**HEARING REPORT**

**CENTRAL INTERCEPTOR EXTENSION - PT ERIN  
TUNNEL - PT ERIN PARK & CURRAN STREET &  
ROAD RESERVE**

**WATERCARE SERVICES LIMITED**

Figure 2 Auckland Council flood hazard mapping

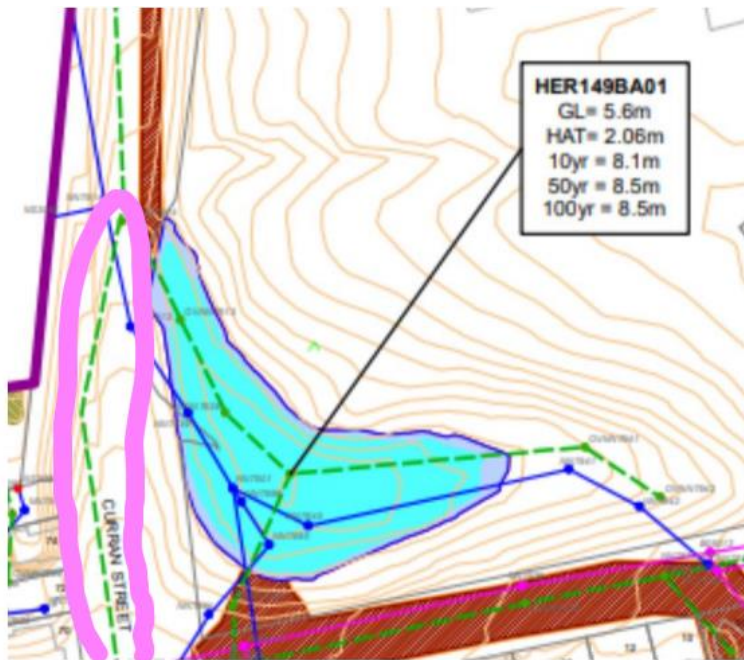
## **S92 E36**

Please review and provide assessment of any effect on the flood plain and overland flow as a result of removing the stormwater pipe under the proposed control building.

**Figure 5 – Location of 70 John Street in relation to the Point Erin Tunnel**

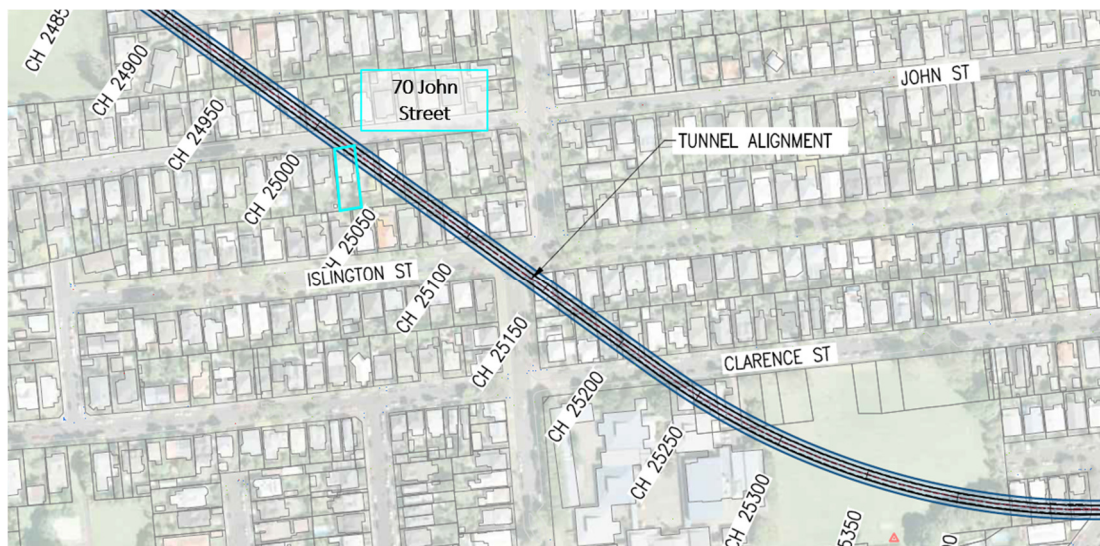
The owner of the dwelling at 70 John Street, as shown in Figure 5 below, has raised concerns regarding “*Potential land subsidence causing damage to our home*”. The property at 70 John Street is located at approximate chainage 320 m of the Point Erin Tunnel.

Based on the long-section of the tunnel presented in Figure 4, the crown of the tunnel is approximately 35 m bgl at the above property. The settlement assessment presented in Appendix B of the T&T Addendum Report indicates that at chainage 320 m, the predicted maximum total settlement is approximately 5 mm at a distance of up to 4 m from the tunnel axis and the predicted maximum differential settlement is 1:3,100. Both of these settlement values are considered to within the “*Negligible to Very Slight*” Damage Category after Burland 2012.

**Figure 7 – Location of 28 Sarsfield Street in relation to the Point Erin Tunnel**

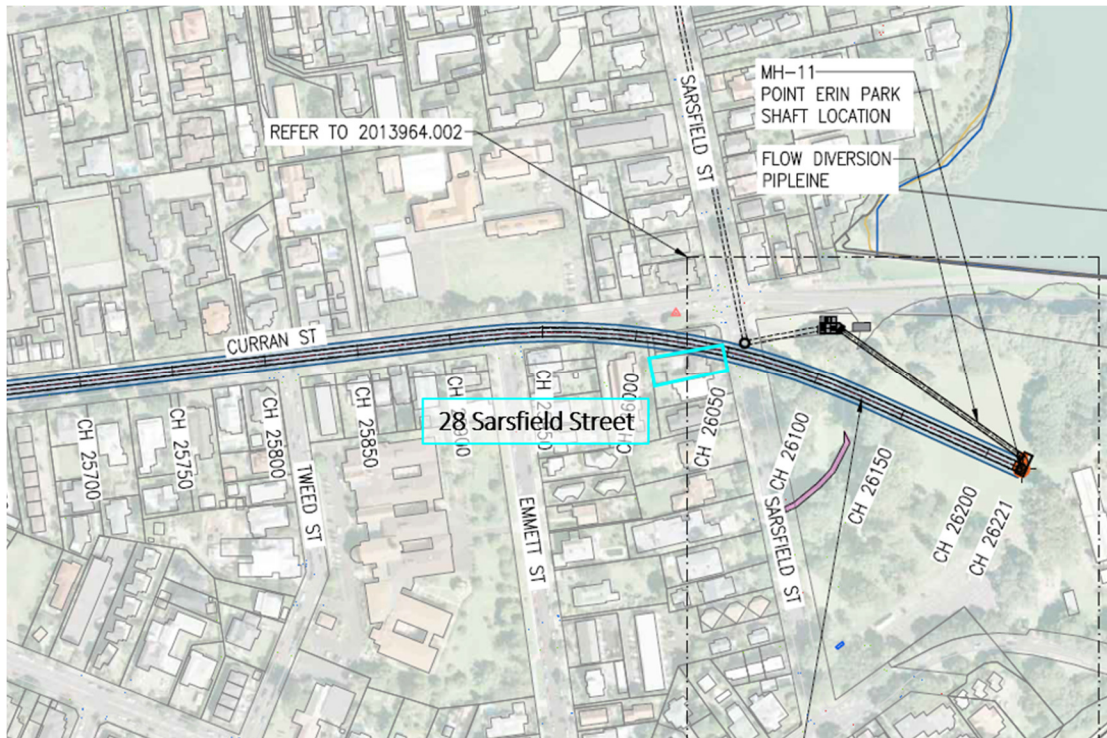
The Trust which owns the dwelling at 28 Sarsfield Street (Figure 7), Herne Bay has raised concerns and they state: “*The depth at which the tunnel passes under Sarsfield Street is extremely shallow, when compared to the depth of the tunnel elsewhere. This will have a huge impact on my property.*” The property at 28 Sarsfield Street is located at approximate chainage 1360 m of the Point Erin Tunnel.

Based on the long-section of the tunnel presented in Figure 4, the crown of the tunnel is approximately 17 m bgl at the above property. The settlement assessment presented in Appendix B of the T&T Addendum Report indicates that, at chainage 1360 m, the predicted maximum total settlement is approximately 6 mm at a distance of up to 5 m from the tunnel axis and the predicted maximum differential settlement is 1:3,100. Both of these settlement values are considered to within the “Negligible to Very Slight” Damage Category after Burland 2012.

**Figure 9 – Location of 57 Clarence Street in relation to the Point Erin Tunnel**

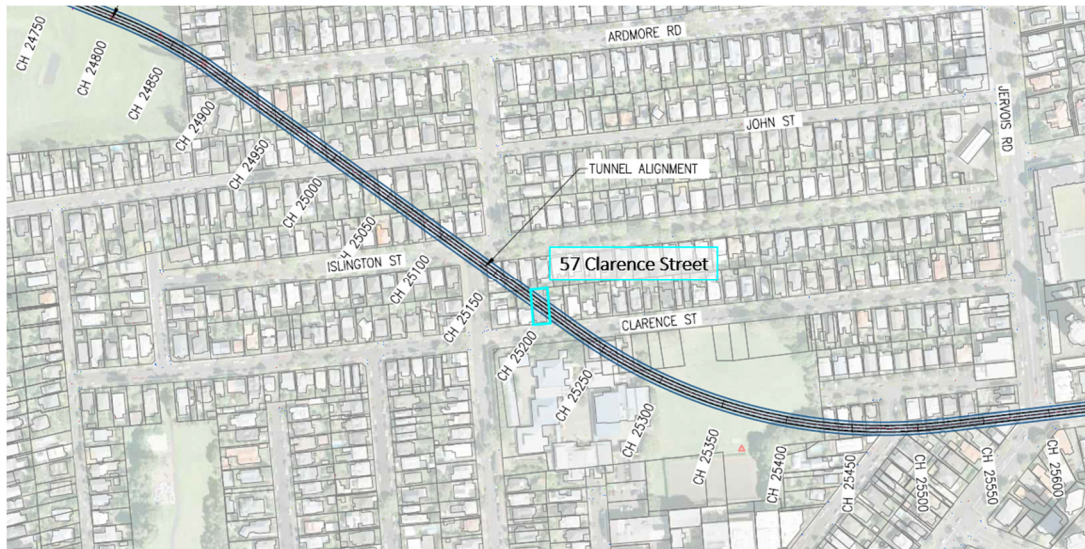
The owners of the dwelling at 57 Clarence Street (Figure 9) have raised concerns and they state: “ ... we oppose the route of this tunnel given the past light industrial use of the land in this area. We feel that without evidence to the contrary, this unknown quantity represents an unreasonable level of risk.” ... “Assurance from Watercare, in writing, that from evidence based testing of the land beneath our home, it considers that our home will not be vulnerable to the tunnelling. Also, at Watercare’s cost, Watercare agrees to undertake a precondition and post-condition survey of our property. This survey to include a photographic record of the inside and outside of the property, and the setting up of markers for building and ground settlement monitoring on the exterior of the property. If it is established that damage has occurred, Watercare will repair that damage to the condition documented in the precondition survey, under Watercare’s liability insurance, to our satisfaction.” The property at 57 Clarence Street is located at approximate chainage 520 m of the Point Erin Tunnel.

Based on the long-section of the tunnel presented in Figure 4, the crown of the tunnel is approximately 37 m bgl at the above property. The settlement assessment presented in Appendix B of the T&T Addendum Report indicates that, at Chainage 480 m, the predicted maximum total settlement is approximately 4 mm at a distance of up to 5 m from the tunnel axis and the predicted maximum differential settlement is 1:3,100. Both of these settlement values are considered to within the “Negligible to Very Slight” Damage Category after Burland 2012.

**Figure 10 – Location of 61 Islington Street in relation to the Point Erin Tunnel**

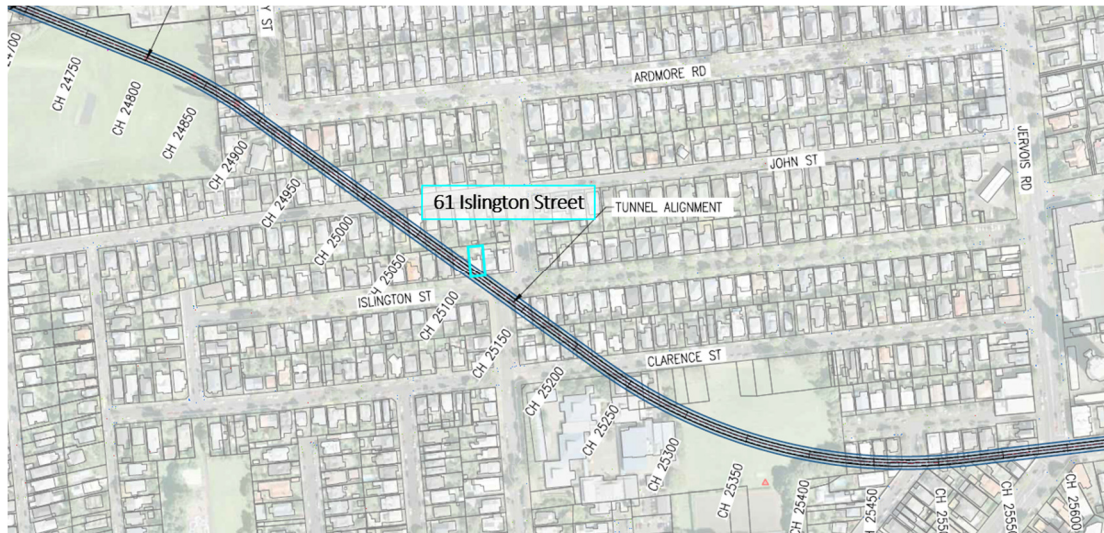
The owner of the dwelling at 61 Islington Street (Figure 10) has raised concerns and states: *“I understand the pipeline has a 100-year life, what guarantee do I have that any damage arising in that time will be addressed by the Council or Watercare.” ... “Watercare have offered a pre- and a post-building survey, if I accept this then am I effectively precluding myself from the Public Works Act compensation.”* The property at 61 Islington Street is located at approximate chainage 400 m of the Point Erin Tunnel.

Based on the long-section of the tunnel presented in Figure 4, the crown of the tunnel is approximately 33 m bgl at the above property. The settlement assessment presented in Appendix B of the T&T Addendum Report indicates that, at chainage 400 m, the predicted maximum total settlement is approximately 5 mm at a distance of up to 4 m from the tunnel axis and the predicted maximum differential settlement is 1:3,100. Both of these settlement values are considered to within the *“Negligible to Very Slight”* Damage Category after Burland 2012.

**Figure 2: Conflict between construction vehicles and pedestrians – east access**

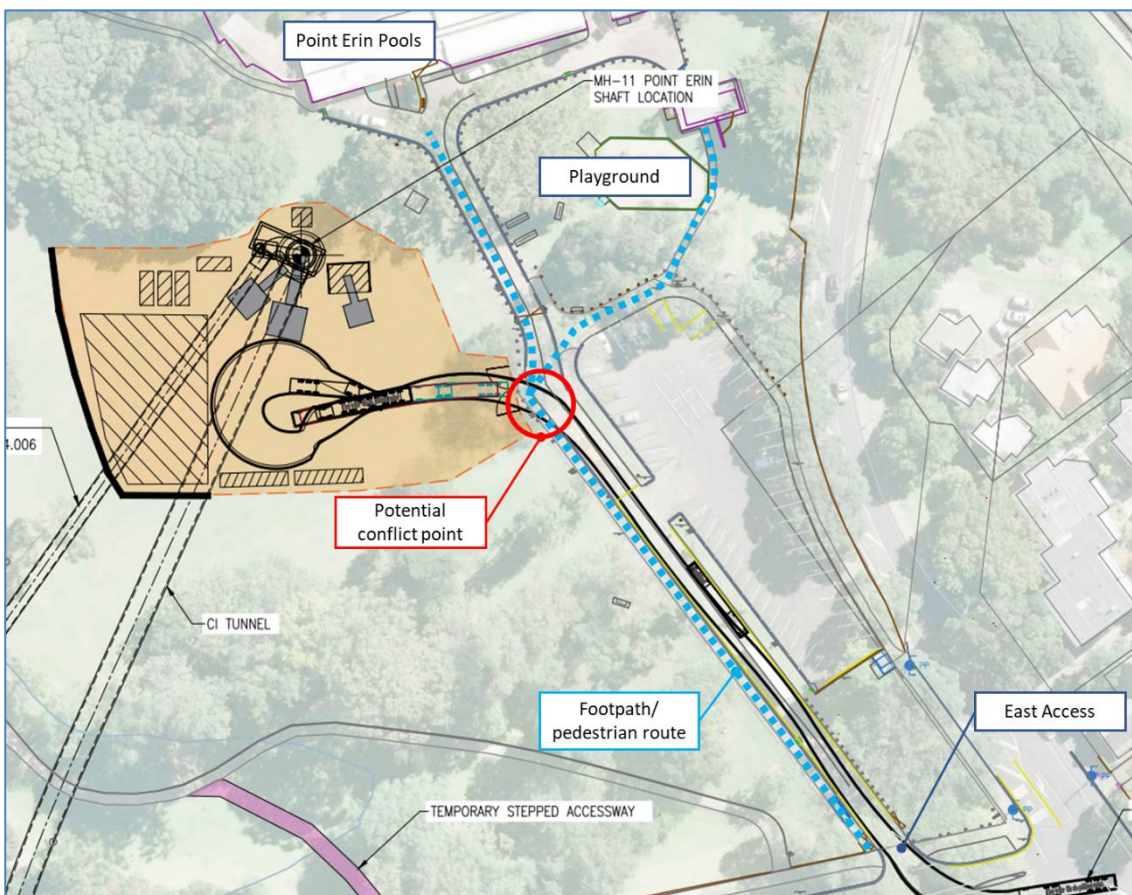
Throughout construction pedestrian access to Point Erin Park, including to the pools and the carpark, will be maintained via the footpath at the eastern side of the park (adjacent to the pools access road). The footpath will remain relatively unchanged, apart from the vehicle access to the main construction area which will cross the footpath. This will create a conflict between construction vehicles and pedestrians using the footpath as shown in Figure 2:

**Figure 3: Temporary footpath closure - west access**

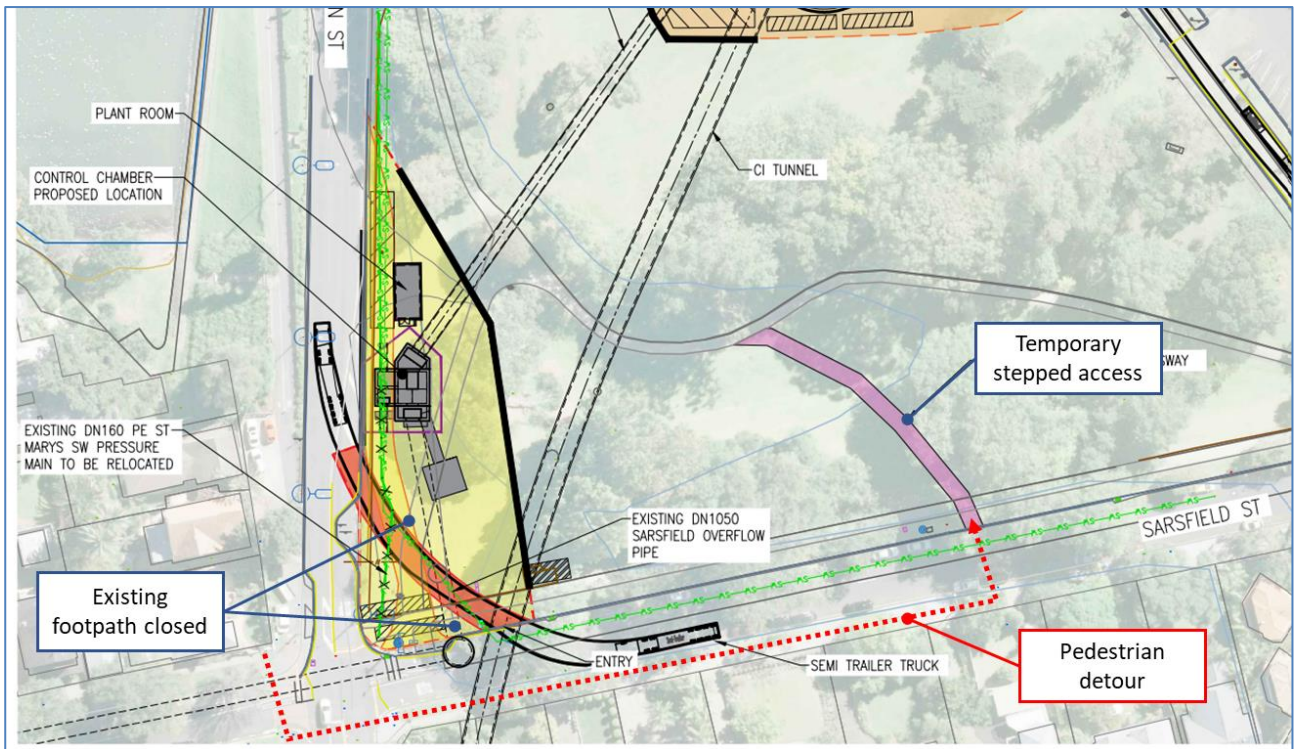
The footpath at the western end of Point Erin Park will be closed throughout the construction period, as will the section of the footpath on the northern side of Sarsfield Street immediately adjacent to the southwestern construction area access, as shown in Figure 3.
